Re: Public Comment Overview - File No. 2207-019 / 6950 SE Maker Street / Parcel
No. 9350900620

We are commenting on this proposed project because we believe the GFA calculation and the existing grades designated by the applicant do not comply with the Mercer Island City Code (MICC). We also have several concerns and questions for the City that pertain to the geotechnical and storm drainage report of which we request be answered. Additionally, due to the complexity of the proposed project, site considerations by the geotechnical consultant, and tight confines of Maker Street, we are requesting the City require a Construction Management Plan be filed. And lastly, based upon our understanding, the MICC tree code may have been violated, and we've provided information pertaining to that issue.

Gross Floor Area (GFA) - (MICC 19.02.020 Development Standards / Appendix B - Basement Floor Area Calculation)

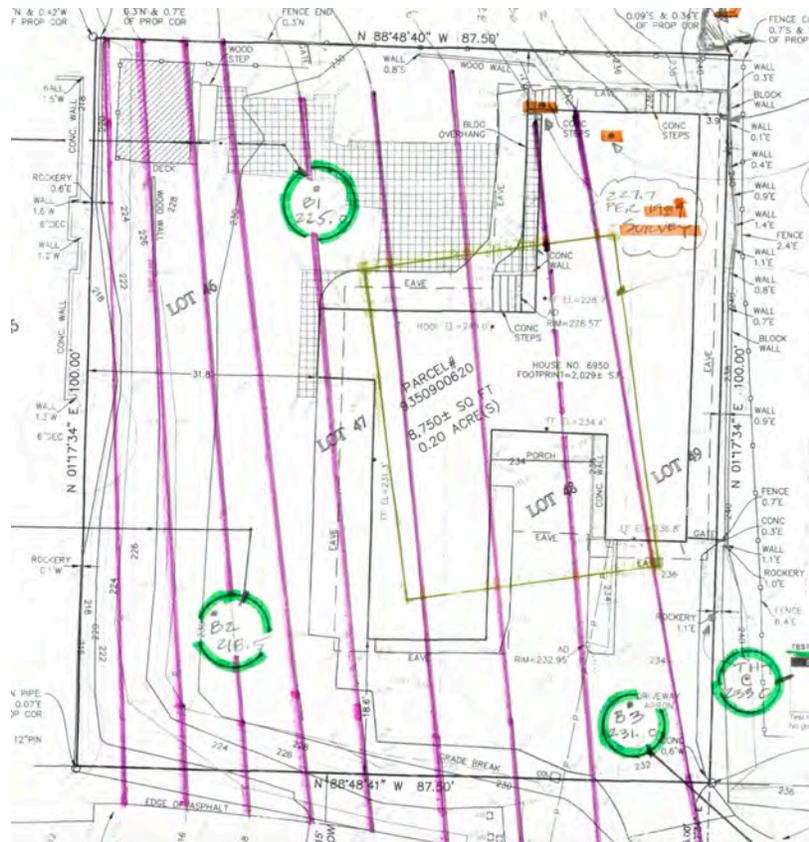
Lastly, the contours from the survey can be straight line interpolated with the contours of Maker Street. Maker likely received very little grading and filling along this stretch because of its steep course westward. Its contours lie mostly perpendicular to the fall line indicating that the road follows the steep slope downward with very little alteration. (In fact, this was corroborated by comparing a 60 year-old topographical map of First Hill and a not yet paved Maker Street with the current Lidar imaging available on the City’s GIS mapping portal.)

From this simple interpolation, the original topography of the 6950 site really takes shape, and again, is what you might expect both on paper and if you were out on site. Yes, the linear contours (highlighted in pink) lack the natural meander one would get had several shots been taken for each contour. But by the same token, all three parcels are laterally aligned with respect to the steep slope orientation and the contours line up in way that is expected. The adjusted existing grade for the borings and test holes are markedly in the ballpark on the 6950 site. And the basement floor spot elevation is within a foot of the floor elevation taken in the 2021 survey.

Photo 2 and Photo 3 from Stormwater Drainage report below. Note: Due to elevations and slope, No stormwater run-off is able to reach either culvert.

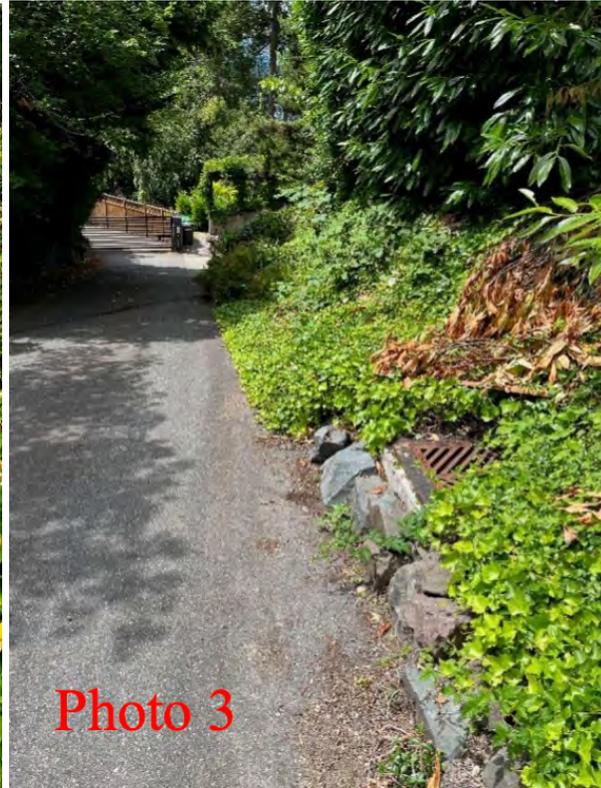
The challenge for the subject property, 6950 SE Maker Street, is that **neither** catch basin in Photo 2 and Photo 3, catch runoff from the subject property or the street, SE Maker. The one

catch basin just east of the driveway (Photo 2) is at a higher elevation than the subject's driveway and SE Maker Street. It was completely grown over from nonuse and recently cleared from weeds, i.e. St. John's Wort and ivy. This culvert doesn't collect rainwater coming down Maker Street due to the location and elevation.

The catch basin in Photo 3 is elevated in the rockery. The only way for this basin to collect stormwater is if water collection was directed in pipes to this culvert/catch basin. This storm drain is located midway below the subject property but is not located at road grade.

Therefore, we believe that the subject property should be required to tightline/pipe all stormwater during construction and construction runoff into one of the unused storm drains. In that case there is less chance that the construction project stormwater would breach the existing berms/curbs and overwhelm the two functional culverts located at 7030 SE Maker Street. See photos below and Appendix.

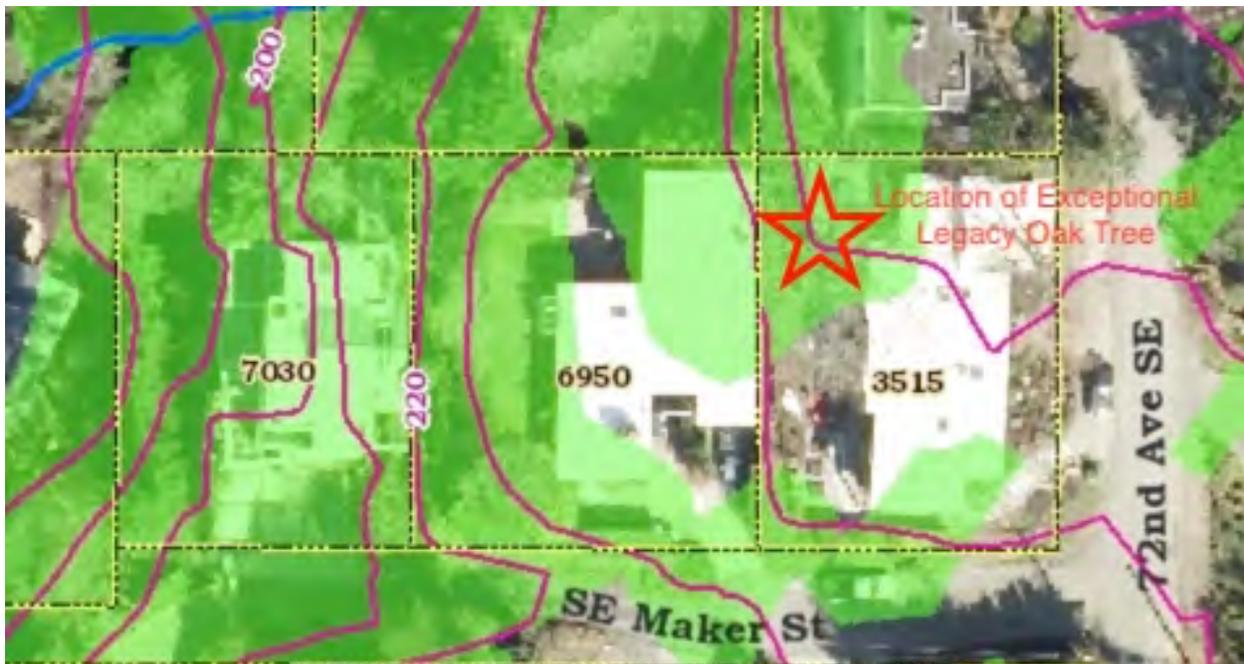
On November 9, 2021, P'n'D Logging and Tree Service cut a significant portion of her neighbor's Exceptional tree. One week after cutting this Exceptional Tree, a Pre-Application Meeting (PRE21- 053) was held with the City (November 16, 2021) for the express intention to either remodel the house and add 1,000 sq ft., or tear down the house and rebuild.

This Red Oak has a diameter of 46 Inches (measured by owner) or 3' 10" and is located on a mapped critical area (indicated in green on map) on neighbor's property (3515), adjacent to (6950) as shown on the map below:

The cutting was severe resulting in a tree that was imbalanced and significantly damaged.

AVERAGE GRADES JAN
 BUILDING ELEVATION CALCS:
 FINISH GRADE TO BSMT LEVEL.

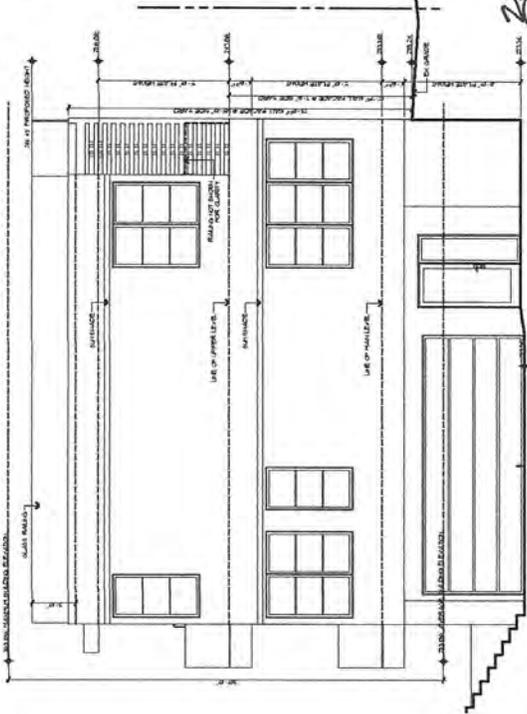
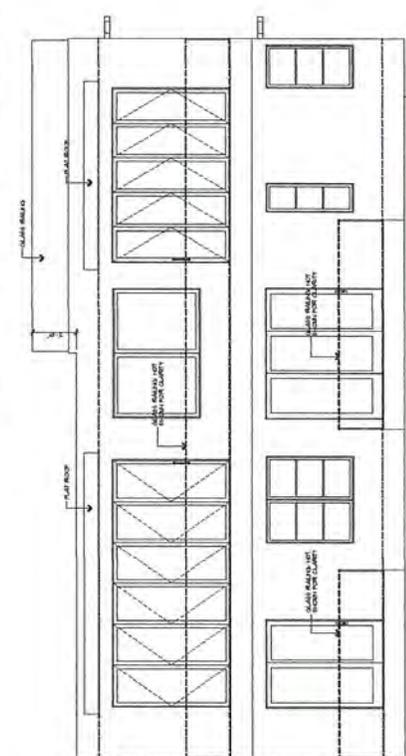
We determined that 51% or 803 sf of 1,575 sf basement/garage should be excluded from the GFA - not 100%. Our adjusted total is 3,498 + 772 basement inclusion = 4,270 sf which exceeds the 40% threshold.

Though the existing grade elevations were not shown on the three of the elevation drawings, existing elevations were used from the survey drawing to gain approximate grades. And where "proposed finished grades" were lower, as per Appendix B - Basement Floor Area Calculation, we used those at the garage front and entry and the basement patio door. A copy of our calculations are included in the attachments.

FOR SAKE OF BREVITY - 1575 # X .51 = 803
 100% OF BSMT WALL COVERED
 803 MAY BE EXCLUDED

APPROX. 55% COVERED
 81.5
 35 + 45 + 45 + 35 = 51% COVERAGE

TOPOGRAPHIC & BOUNDARY SURVEY

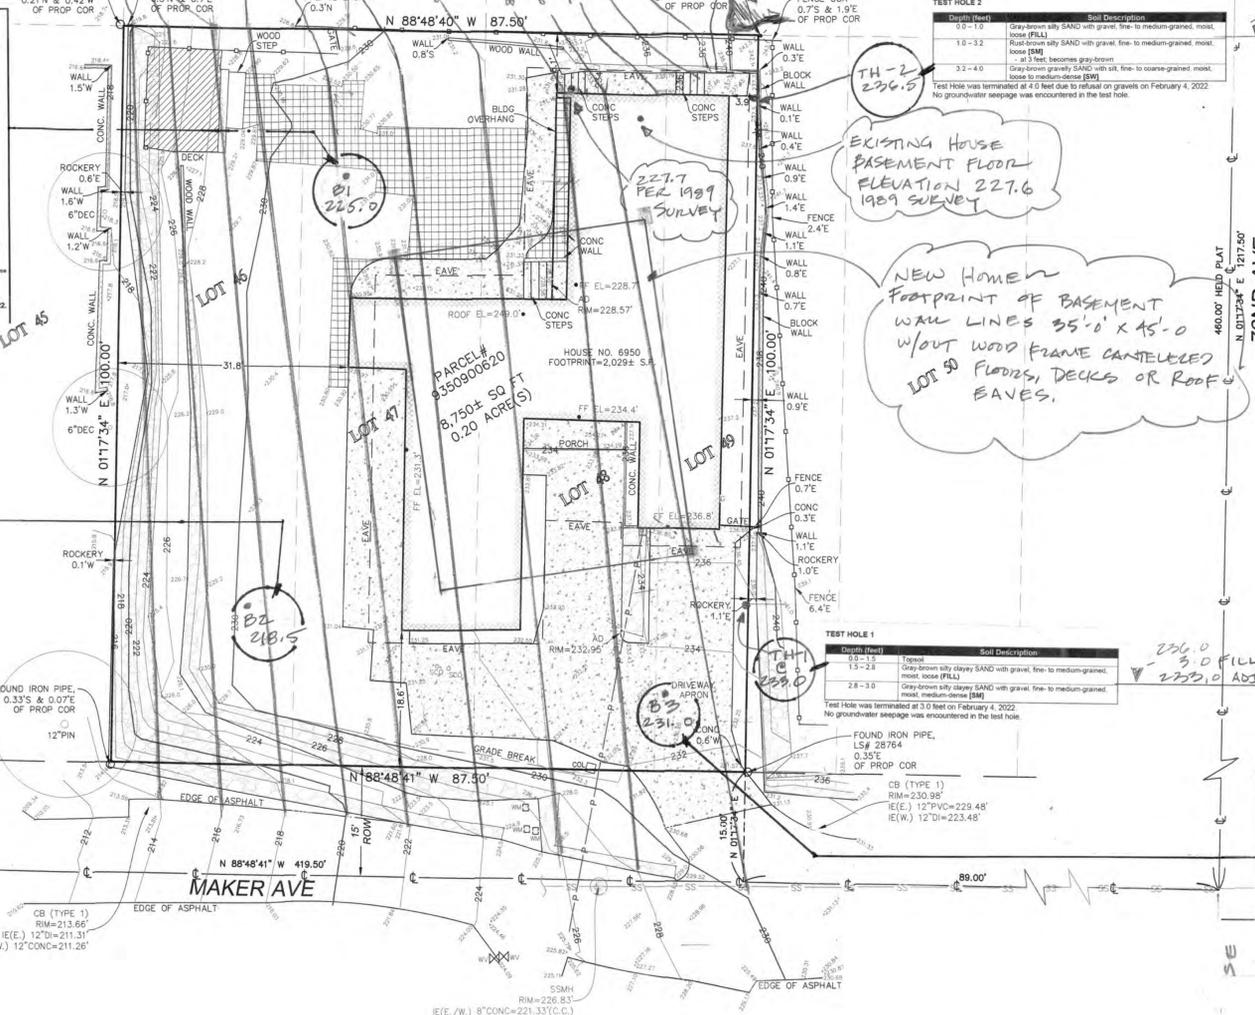
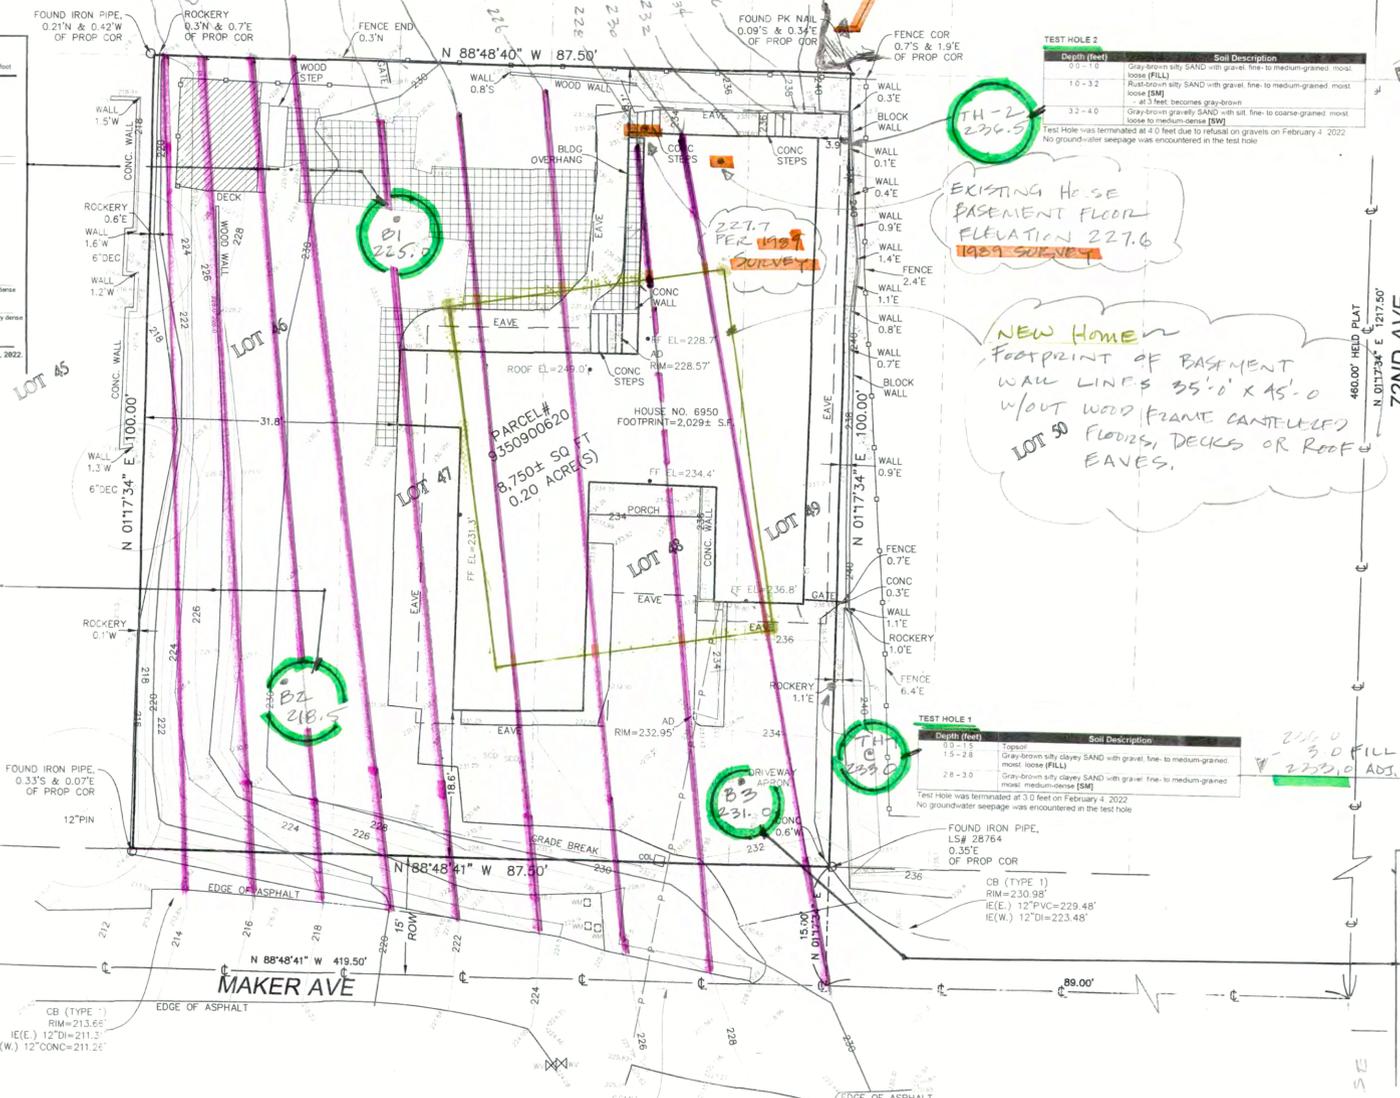
(Please note, we do not agree that most of the spot elevations and contours shown on Terrane sheet 1 of 1 meet the MICC definition of existing grade, however we did use them to illustrate our points above.)

A majority of the spot elevations and contours on the survey plan, Terrane sheet 1 of 1, which are designated by the applicant for design of the proposed project, do not meet the MICC definition of *existing grade* and more extensively, *alteration* and therefore, do not comply with the MICC.

Having researched and reviewed all of our data, including that of Dan Grove's, we believe there is enough concrete evidence to show that the designated existing elevations used for design and proposed construction do not fit the definition of *existing grade* and *altered* and thereby do not comply with the MICC. In addition, by virtue of the geotechnical and survey information we provided, we believe the existing grade, for example, on the west portion of the proposed structure lies many feet lower than the designated existing grades currently proposed. At a minimum, 224.0 - 225.0 seems highly plausible, but in all likelihood it could be much lower than that.

231.0
 - 6.0 FILL MATERIAL
 225.0 ADJUSTED ELEVATION

230.0
 - 11.5 FILL MATERIAL
 218.5 ADJUSTED ELEVATION
